Notice of Allowability

10/502,329

KOTTER LENDERS

EXAMINER'S AMENDMENT

FIG. 4.

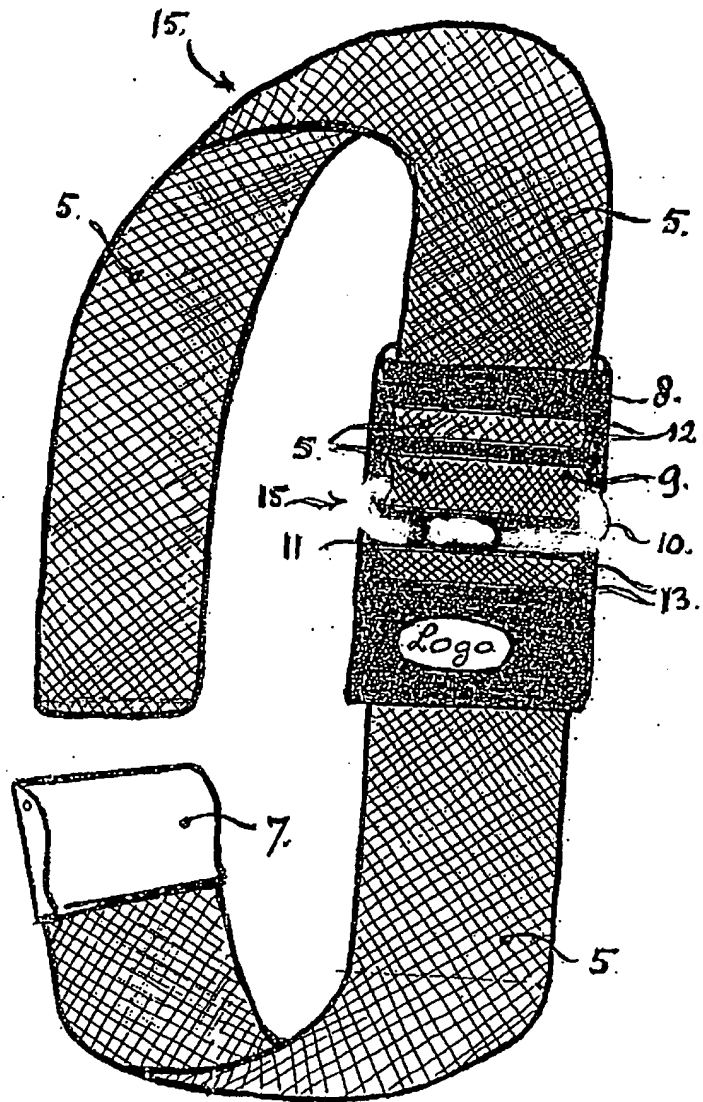
j. In the paragraph beginning at page 5, line 15 as amended 2/28/07, in line 17, "(not indicated)" was changed to, --as well as a round wire through a bore (shown schematically in Figure 4). The locking mechanism is one of stainless steel and

2. The following changes to the drawings have been approved by the examiner: In Figure 4 of the replacement drawings, the hatching on lock 11 will be deleted, as lock 11 in Figure 4 is now a schematic showing of the hook, wire, etc. In order to avoid abandonment of the application, applicant must make these above agreed upon drawing changes.
